ADDENDUM NO. 4

DATE: August 22, 2007

Contract 7-C-69; River Garden Park Shoreline Restoration

BORING LOCATION PLAN

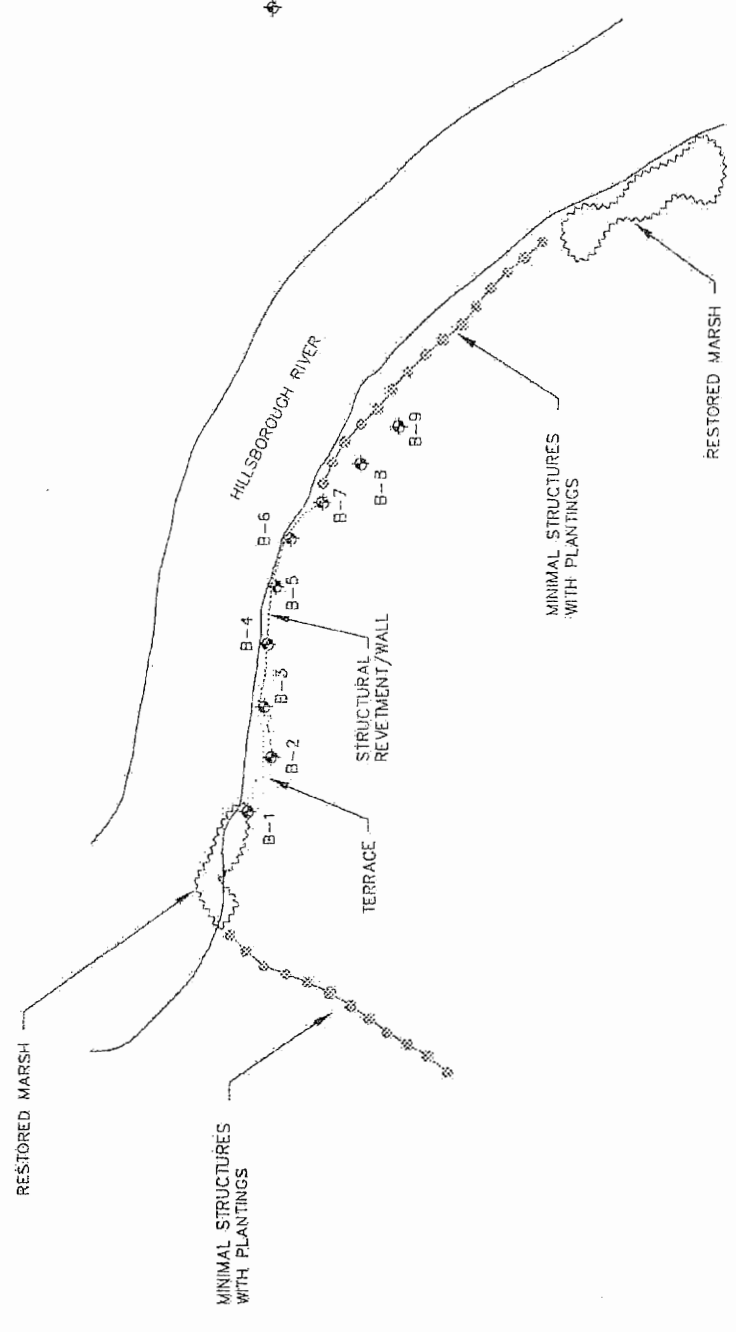
- Item 9: **Tech Spec 02460-3 H Piles Unit of measure for payment– CLARIFICATION:** Payment shall be lump sum price as indicated on the proposal form.
- Item 10: **Soil Analysis/Borings in the area of the H Piles– CLARIFICATION:** a geotechnical report for the project site has been prepared by Professional Services Industries, Inc. (PSI). The reported information includes nine (9) boring locations and their corresponding soil profiles. See report for a figure showing the location of the borings.
